BID Addendum No. Five (5)

PROJECT: Iona Preparatory School
Addition and Alterations to the
Pail Verni Fine Arts Center
255 Wilmot Road
New Rochelle, NY 10804

ADDENDUM NO. Five (5)
Initiation Date: June 24, 2021

Architect's Project No.: 1618
PGA Contact: Danny Lam
dlam@petergisolfiassociates.com
914-478-3677 x 340

Scale	Job No.	Date	Drawing No.
1/8"=1'-0"	20-2723	04/03/2019	M-301
Drawn			
Peter Gisolfi Associates Architects Landscape Architects, LLP 566 Warburton Avenue Hastings on Hudson, NY 10706 914 478 3677			
PETER GISOLFI ASSOCIATES

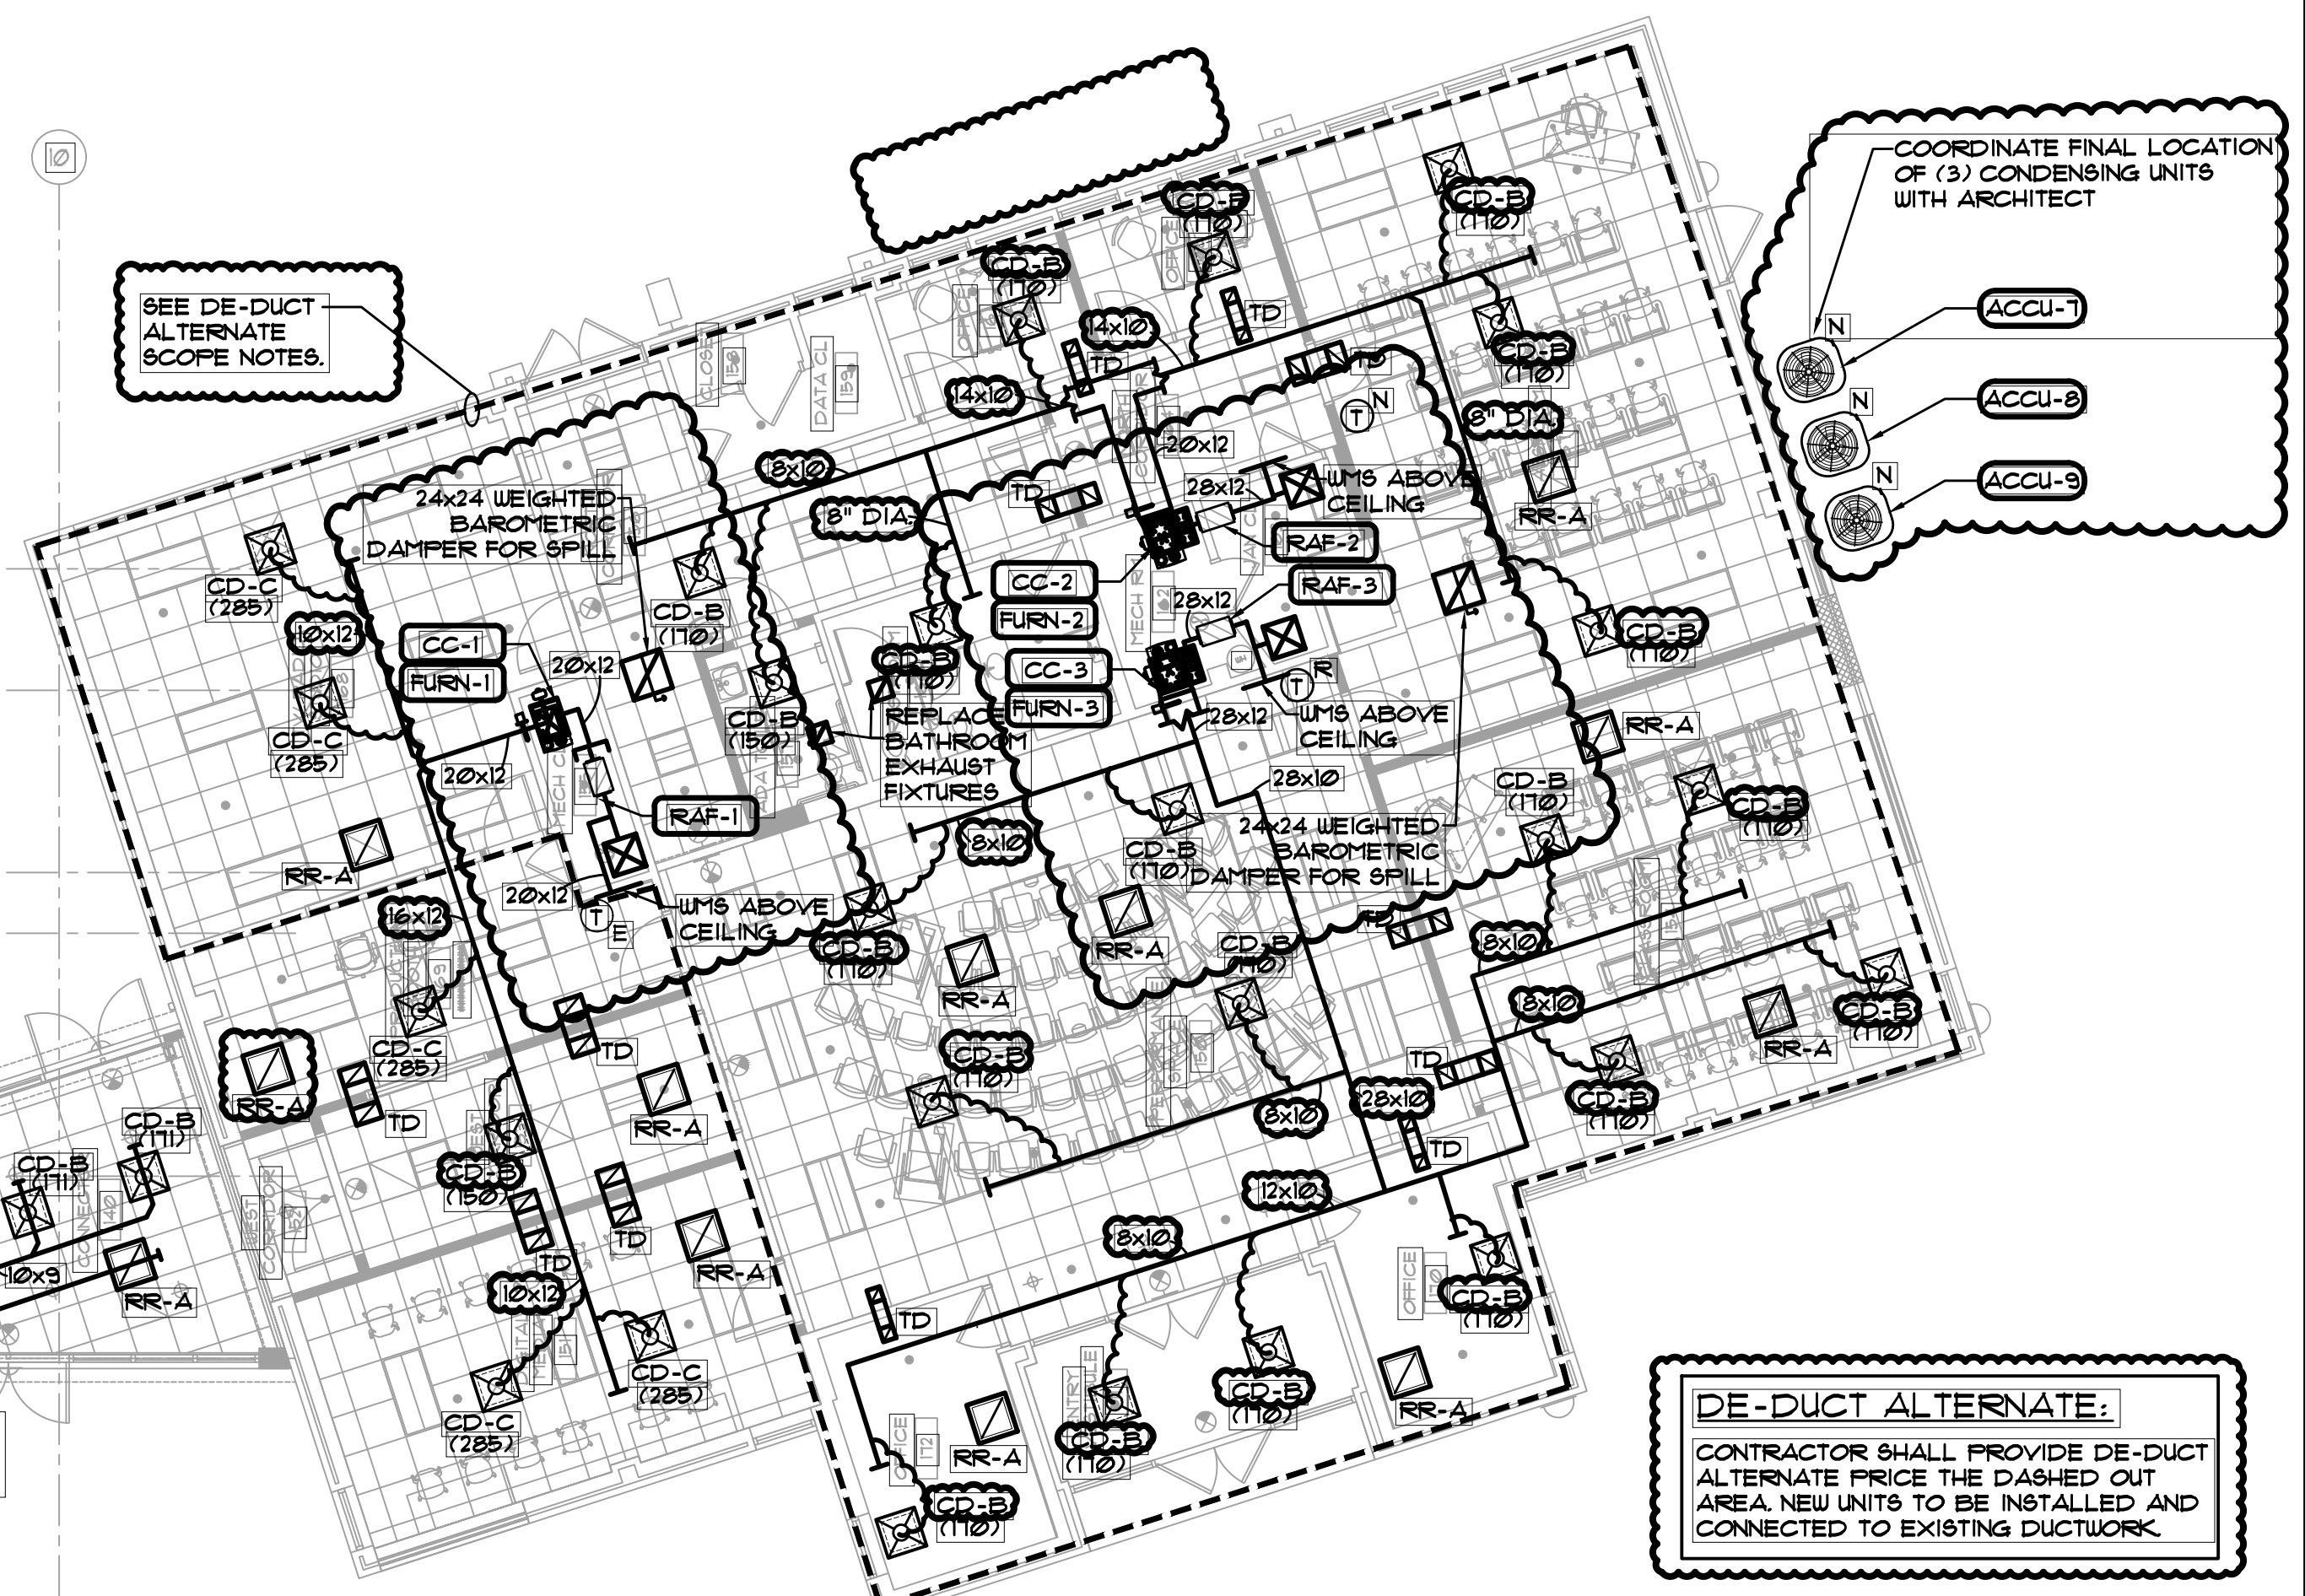
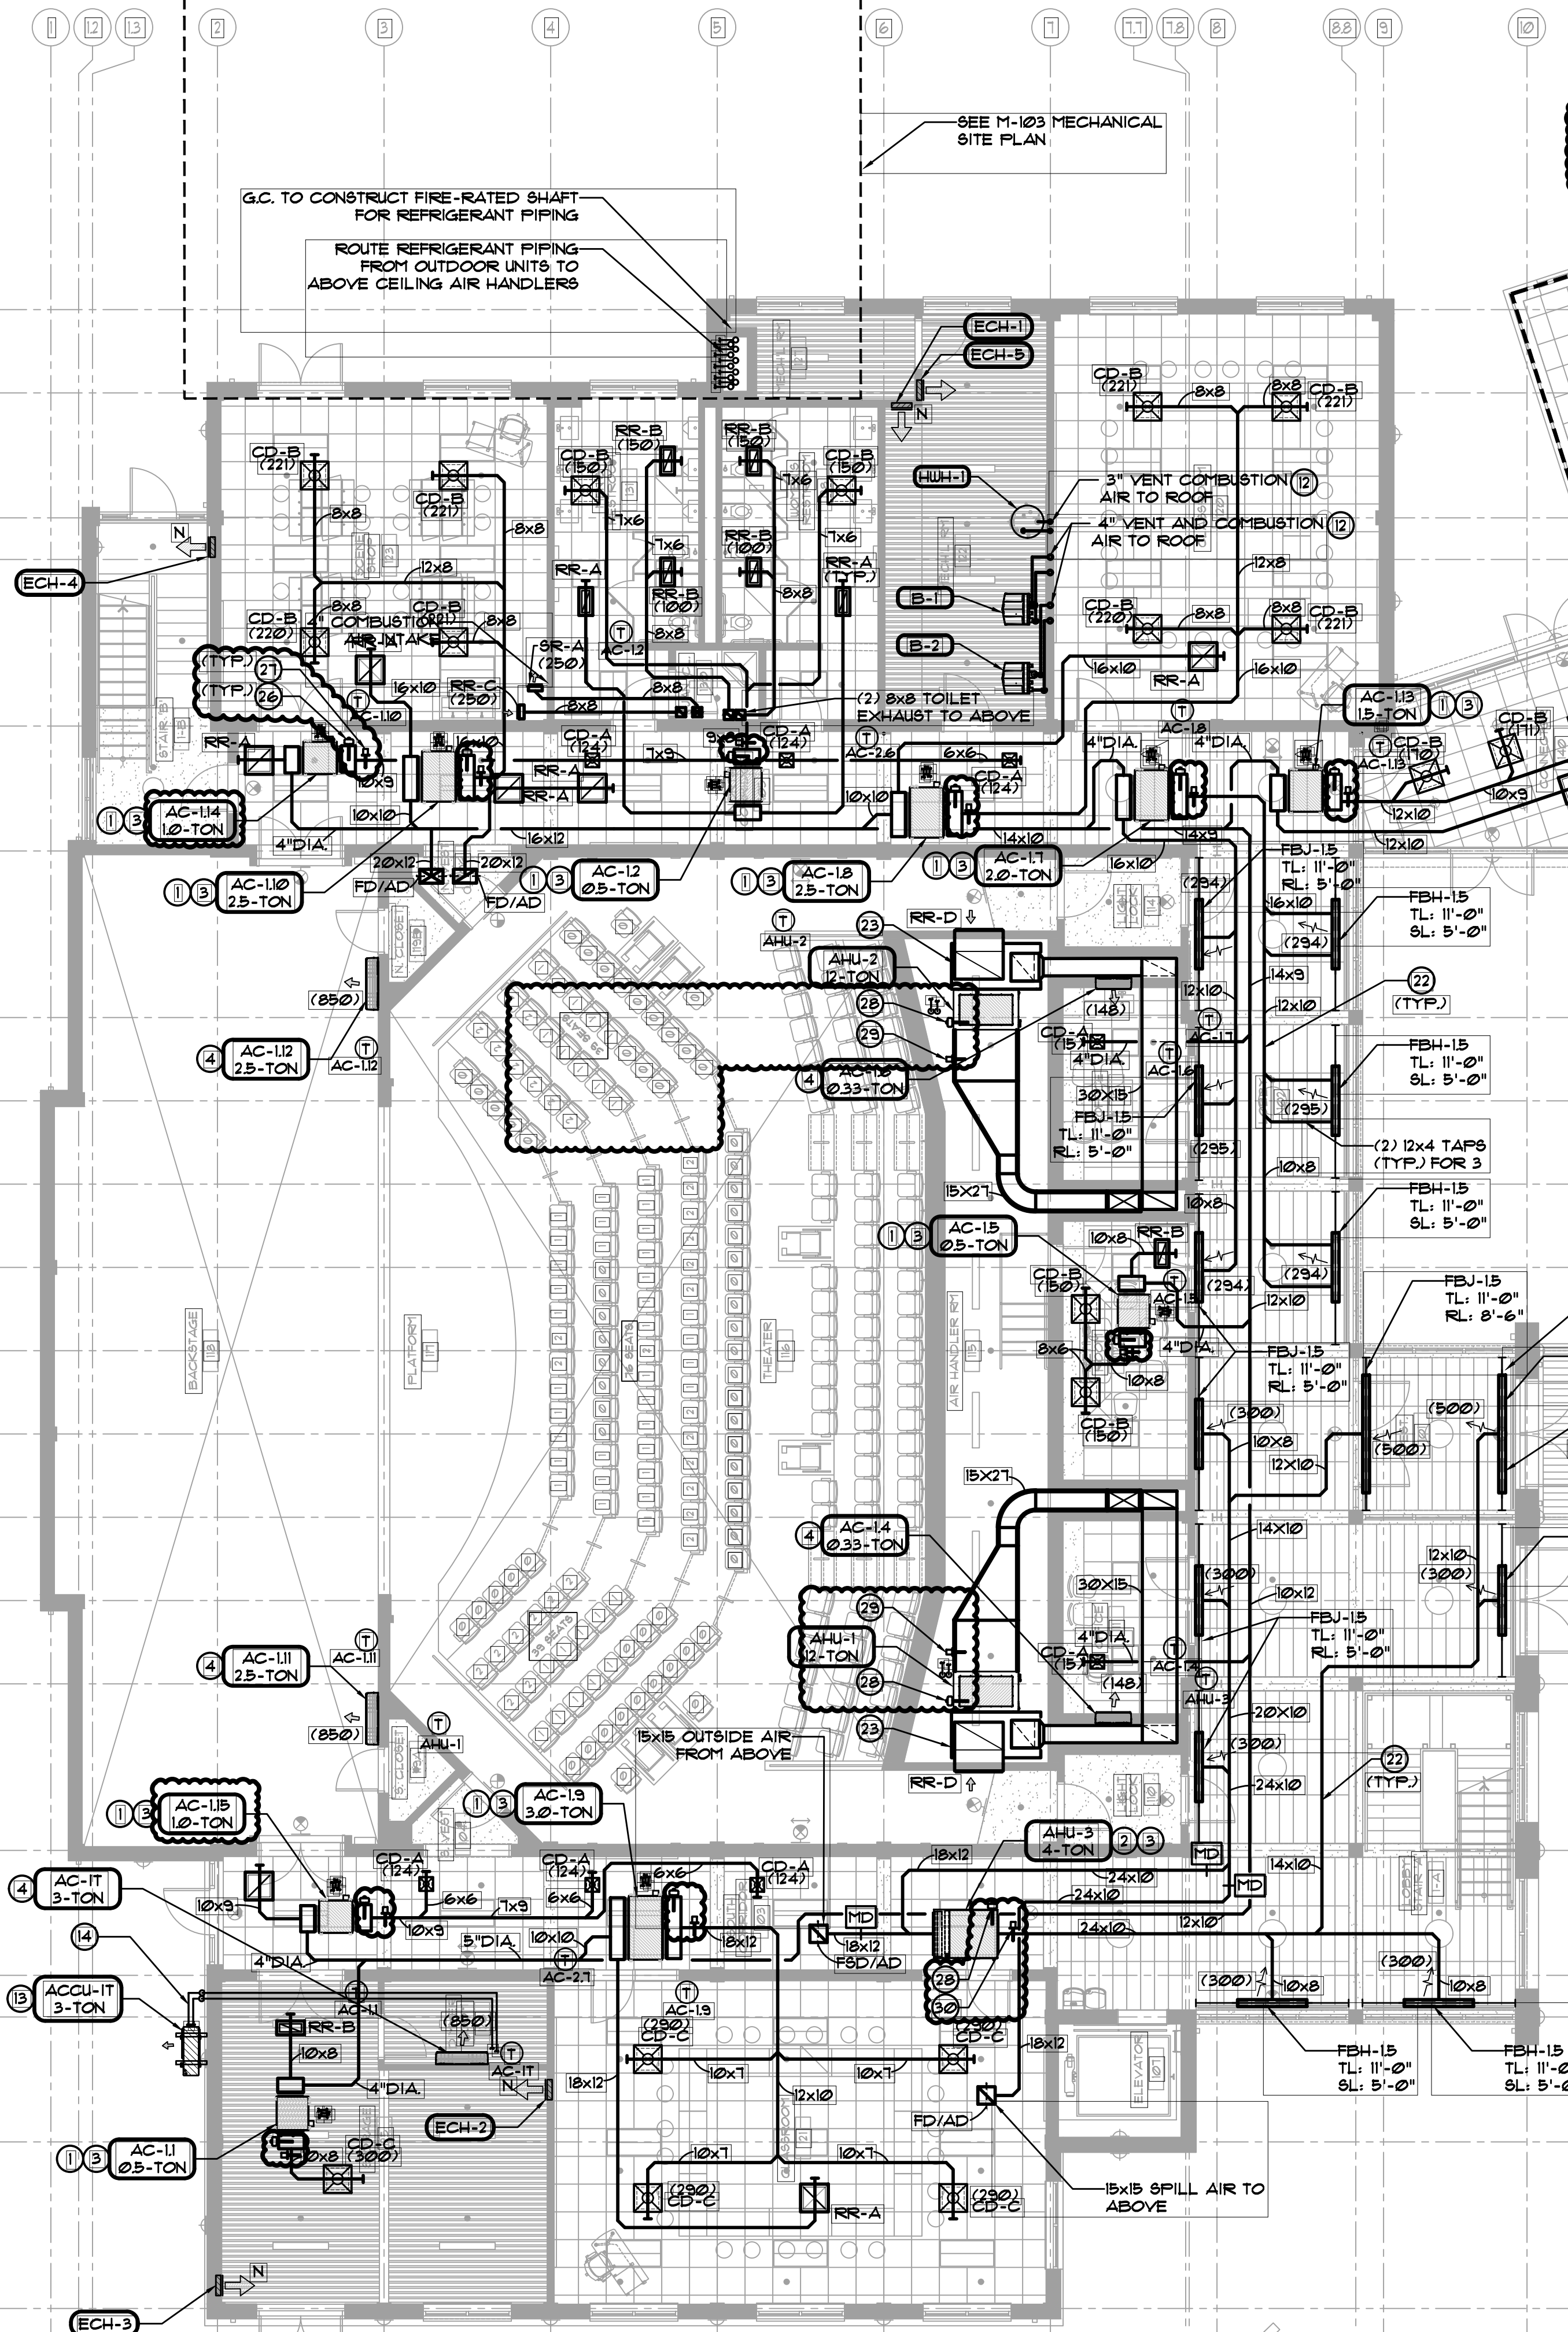
4. See attached revised sheet M-201 with revisions to Verni demolition.
5. See attached revised sheet M-301 with revisions to mechanical construction plan.

Scale	Job No.	Date	Drawing No.
1/8"=1'-0"	20-2723	04/03/2019	M-322

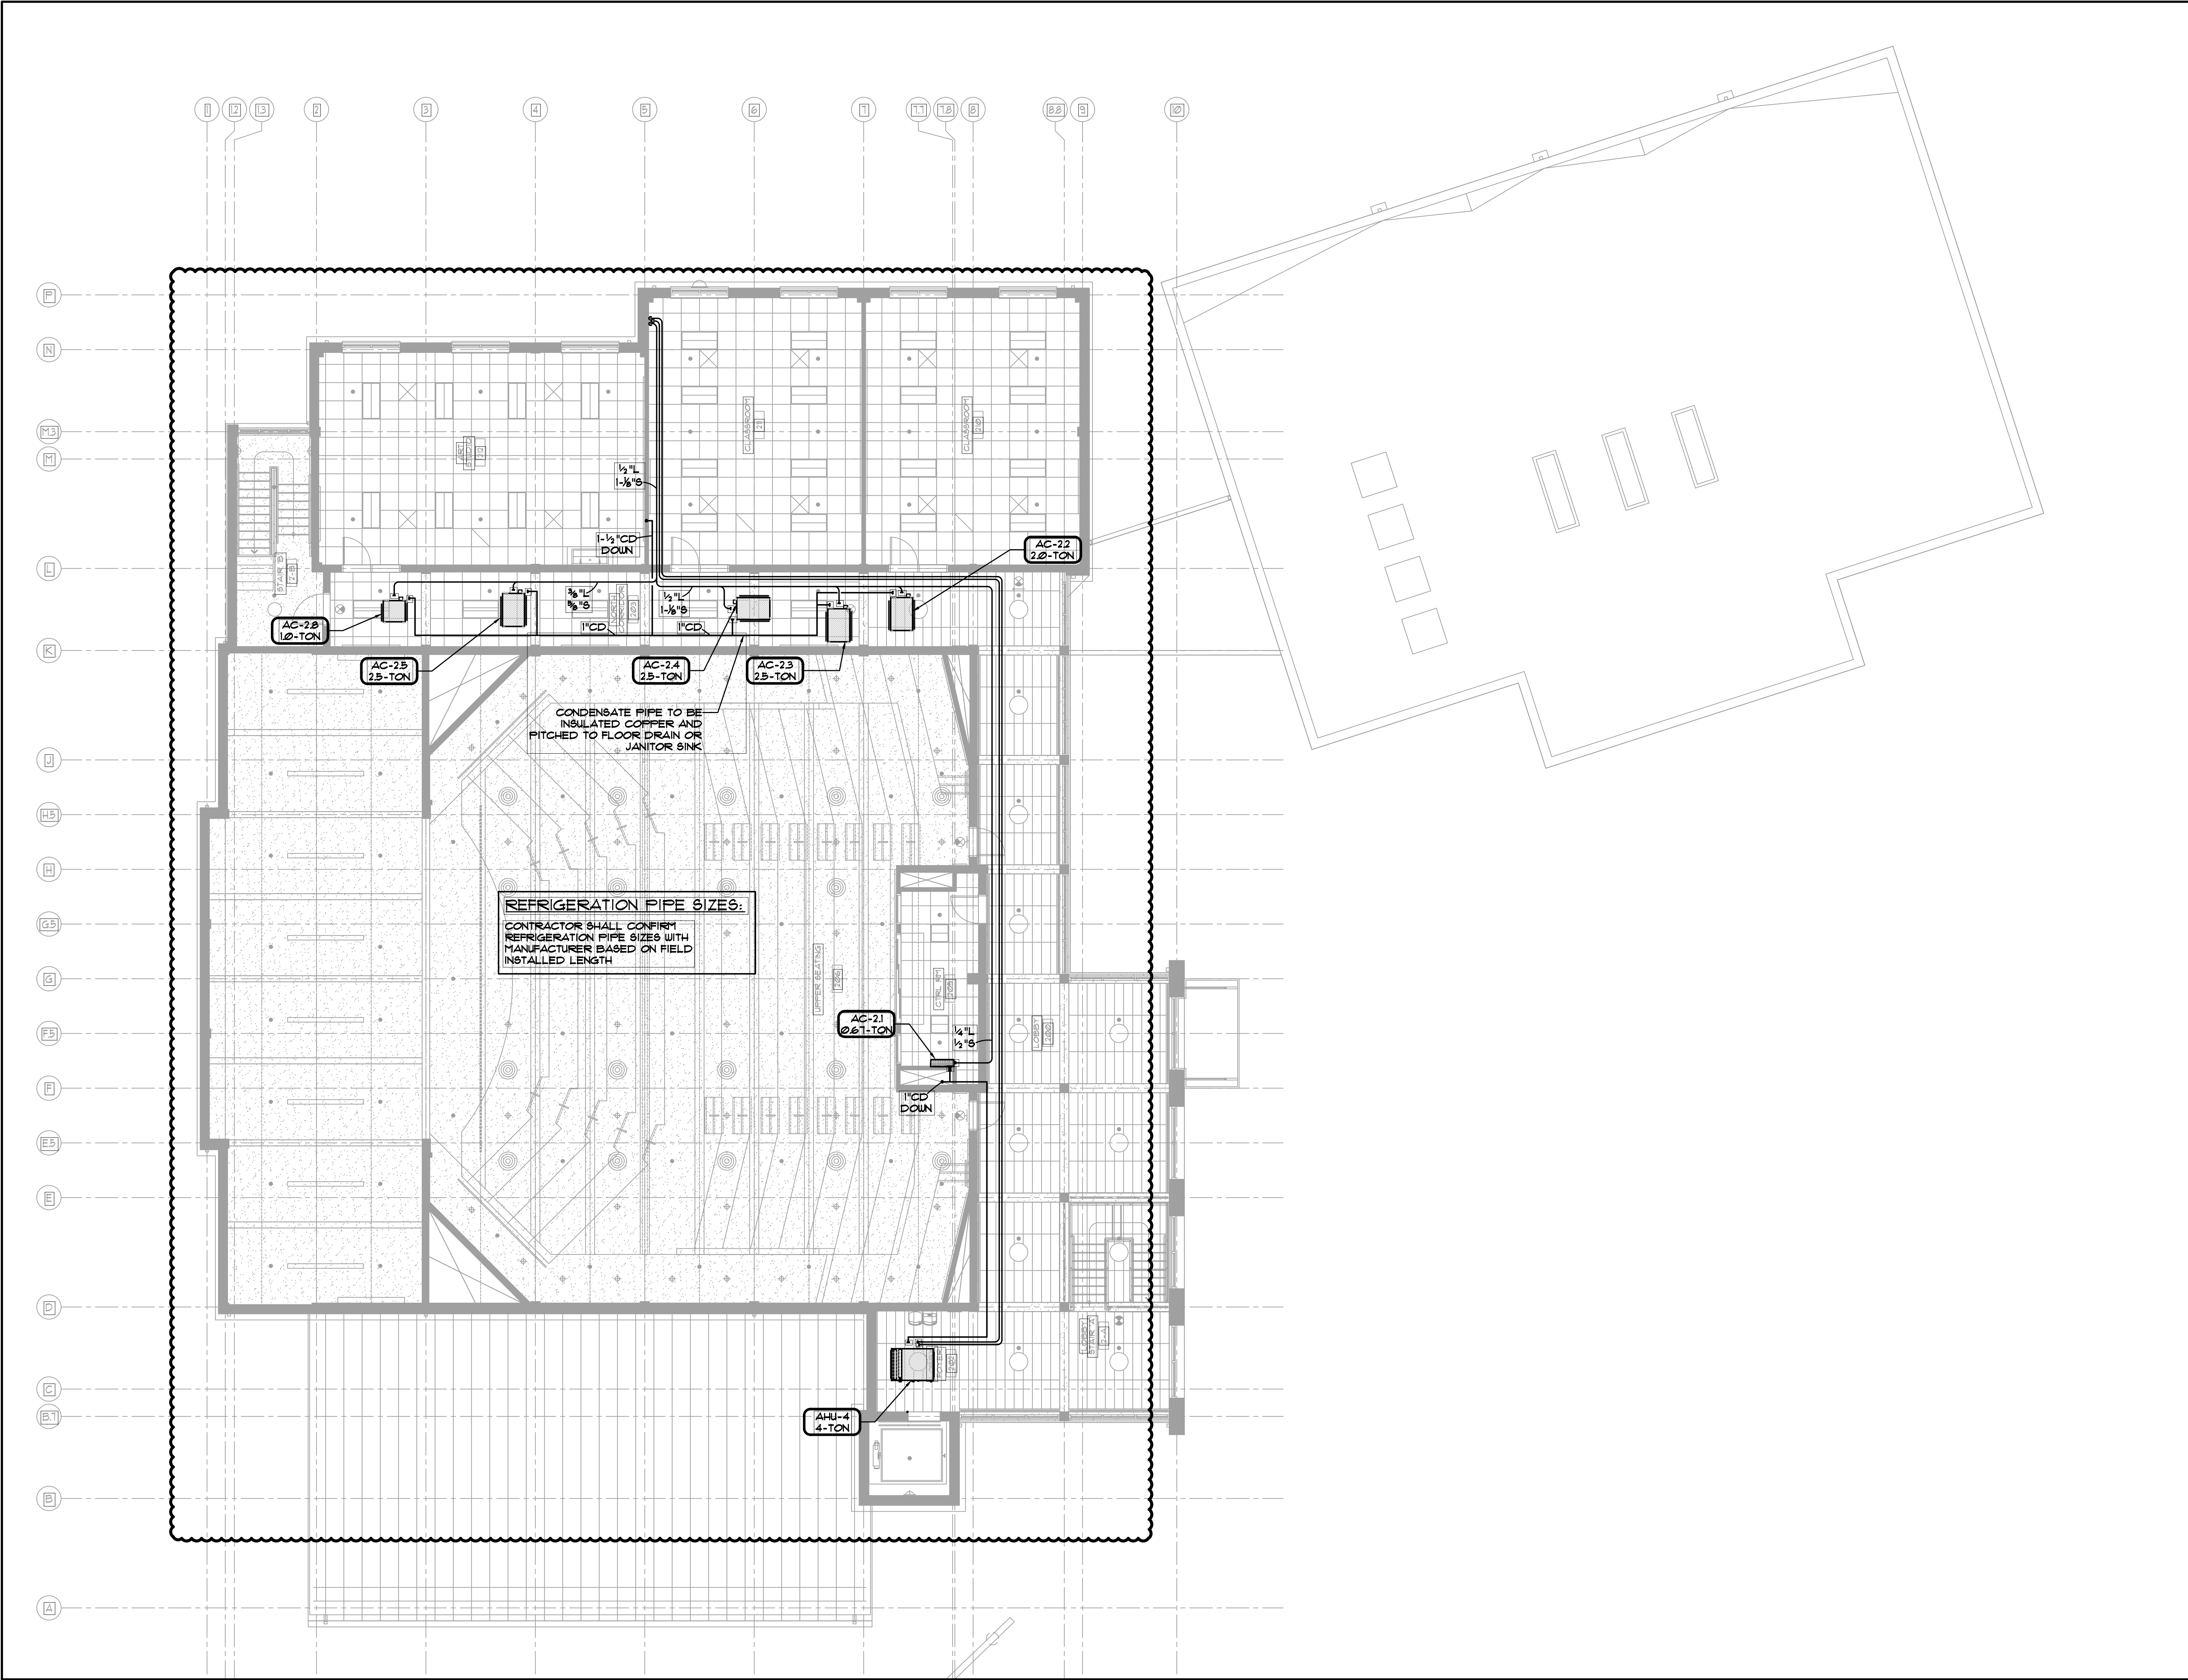
6. See attached revised sheet M-311 with revisions to mechanical piping plan.
7. See attached ADDED sheet M-321 First Floor Refrigerant Piping Plan.
8. See attached ADDED sheet M-322 Second Floor Refrigerant Piping Plan.
